**Regarding
Performance Designs Service Bulletin # 002
Relative Workshop Service Bulletin # 230505.**

SERVICE BULLETIN

Date: 5/23/2005
Service Bulletin #: PDSBLTN-002, RWSBLTN-230505
Subject: Inspection of Tandem VTC-III reserves (VR-360) A Line Attachments and Steering Lines.
Status: MANDATORY

II. Steering Line LST Loop

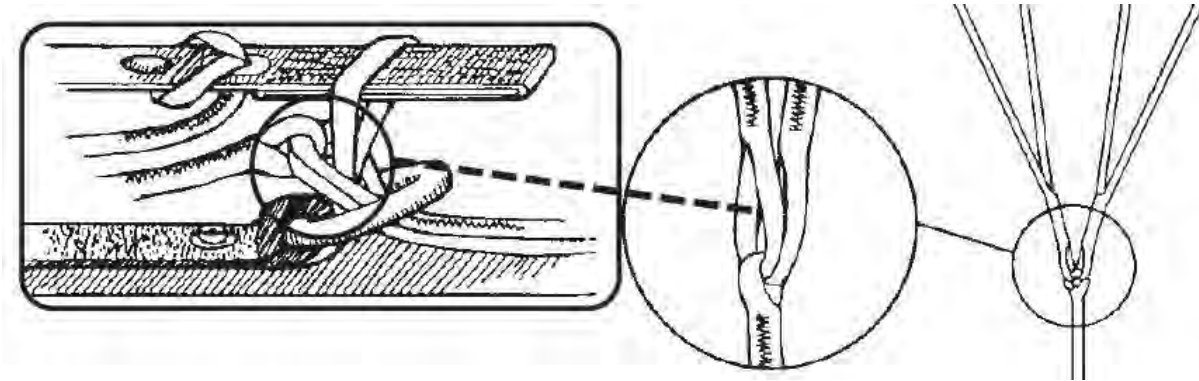
Some VR-360's were manufactured with the lower control line loop to be as large as the upper control line loop at the cascade. While there is no impact to the structural integrity, or performance of the canopy, this situation opens the possibility for the riser brake-setting loop to be misrouted through the lower control line instead of the correct location in the upper control line as shown below. Improperly set brakes can result in brake line failure during opening and unusually high opening forces.

1. Inspect the LST attachment loop per the attached Inspection Procedures Section 2, LST Loop Inspection.
2. If either steering line does not comply with the proper configuration of the loop, the parachute must be brought into compliance by a certificated rigger following the provided instructions prior to placing back in service.

Figure 1 Rib leading Edge Tape Inspection

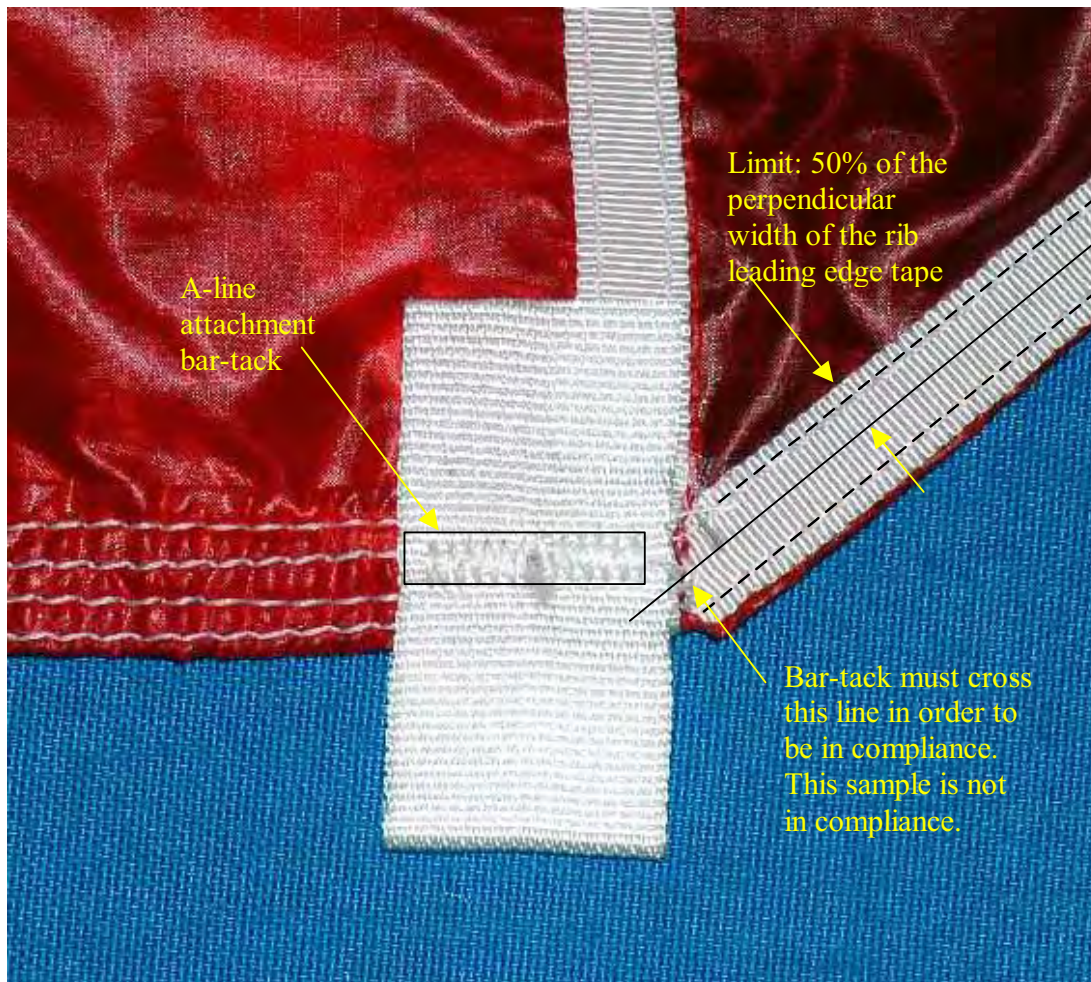
The A-line attachment bar-tack must be sewn through at least 50% of the width of the loaded-rib leading edge tape.

- Using a ruler, find the centerline of the rib-leading edge tape. This may be lightly marked with pencil if necessary.
- Using the ruler, extend the centerline of the leading edge tape to the vicinity of the bar-tack.
- Observe the location of the bar-tack with respect to the tape centerline.

Figure 2- Bottom Skin LE Tape Inspection

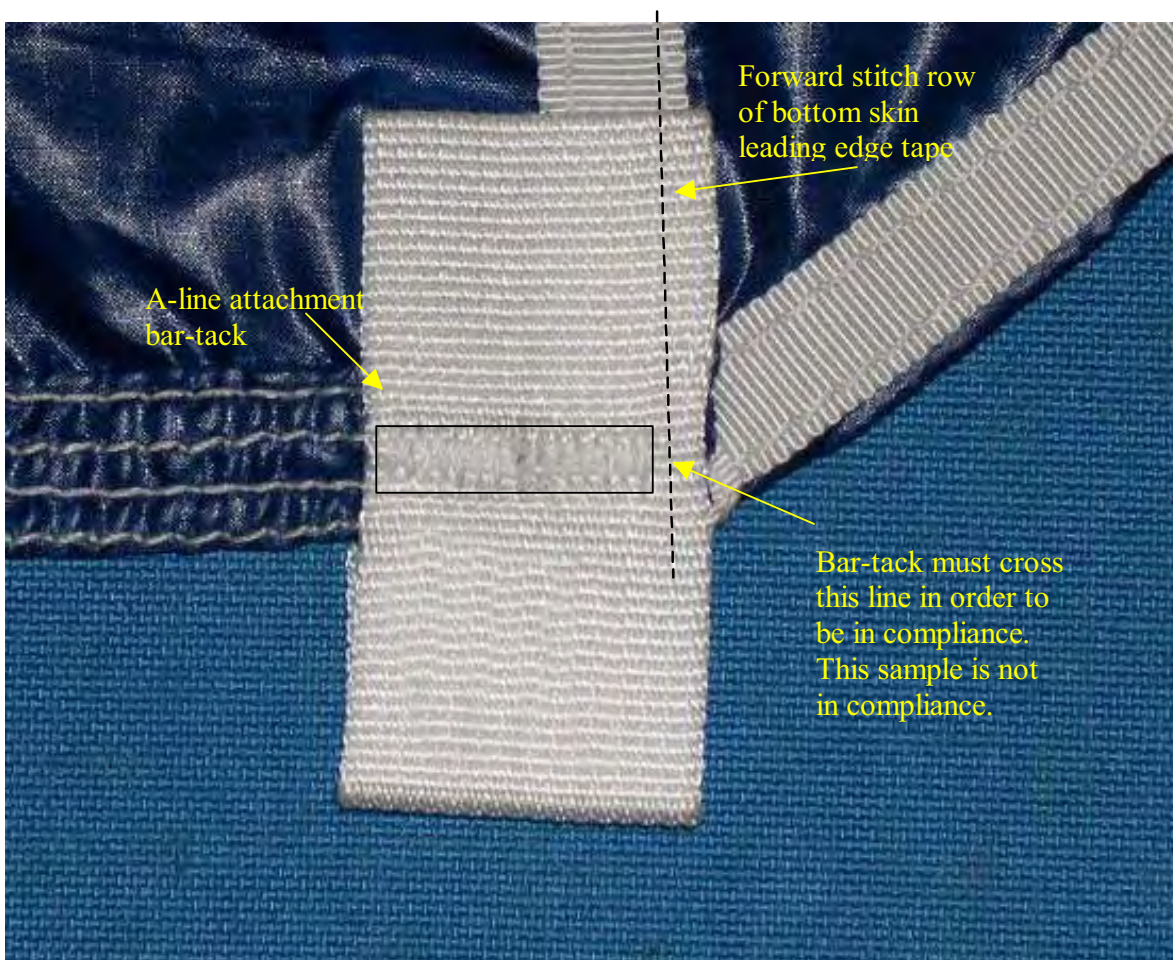
The A-line attachment bar-tack stitching must extend forward of the forward stitch line on all the bottom skin leading edge tapes. Inspect both sides of tab.

- a) Locate the forward stitch row of the bottom-skin leading edge tape.
- b) Using a straight edge, extend the forward stitch line of the leading edge tape to the vicinity of the bar-tack.
- c) Observe the location of the bar-tack with respect to the tape stitch row. The bar-tack may or may not overlap the edge of the line-tab, but it must cross the stitch-row and be going through the tab at this point.

Figure 5 Good LST Loop

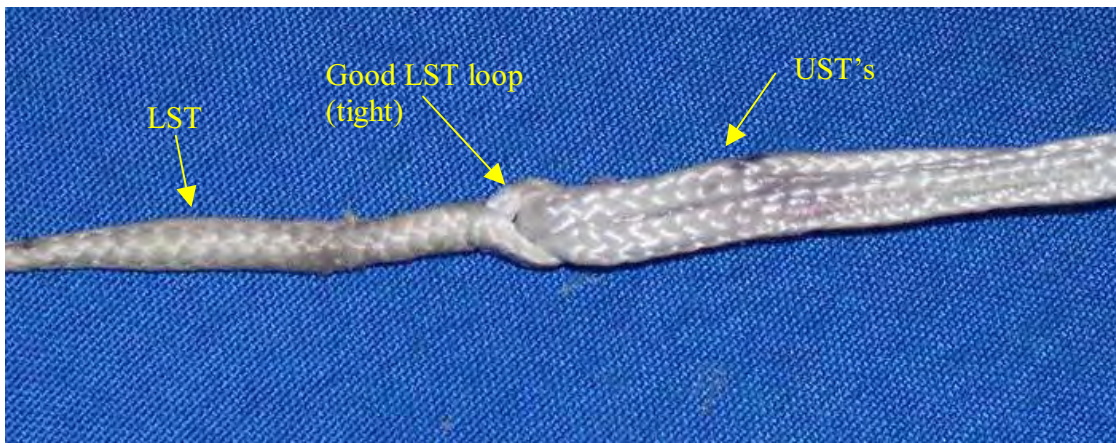
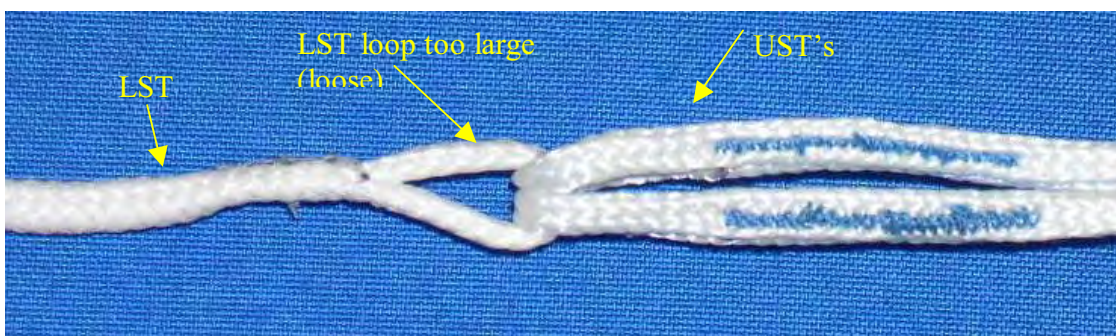
Check each of the LST's (lower steering lines, the line that passes through the toggles) where it loops around the UST (upper steering line). This loop must be small enough that the brake setting loop on the risers cannot be pulled through.

Using Figures 7 and 8, evaluate the LST loops.

Figure 7 Top View, LST Loop Adjustment

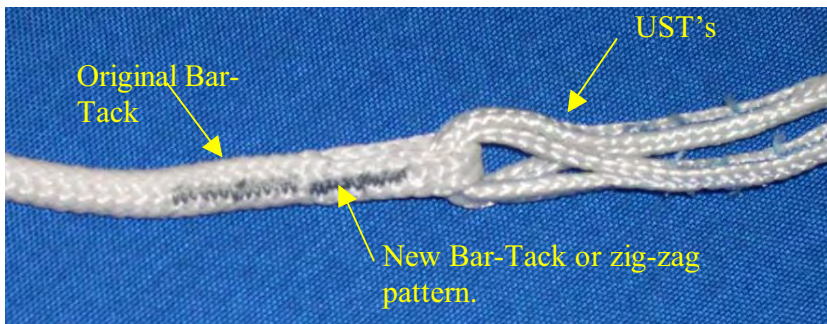
The LST loop may be reduced to an acceptable level by adding a bar-tack or zigzag stitch to reduce the open legs of the loop. The following includes directions for reducing the existing LST loop.

The work must be performed by a certificated rigger. The stitching must be Nylon E-thread. Stitching may be done with a single throw zigzag, double throw zig-zag, or a bartacker with between 28 and 42 stitch conventional or center start pattern. Stitch pattern should be between 1/2" and 5/8" long, and 1/8" wide. For zigzag stitching, the preferred pattern is to start at or near the existing bartack, sew toward the UST, and then reverse back to the starting point. Zigzag stitching shall be 12 to 16 stitches per inch for single throw, and 8 to 12 stitches per inch for double throw.

The stitch shall be installed to the legs of the LST loop between the existing bar-tack and the loop around the UST lines as shown in Figure 9. The UST's may be left in place while this work is done, given sufficient care to avoid stitching thru the UST material.

Figure 8 Side View, LST Loop Repair.

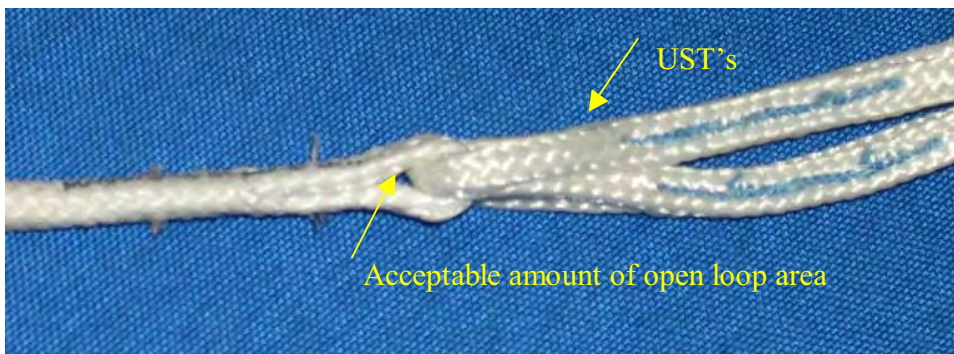
The stitching shall not overlap the existing bar-tack or penetrate the UST material passing through the loop. See Figure 10. A small amount of open area within the loop is permissible after the repair.
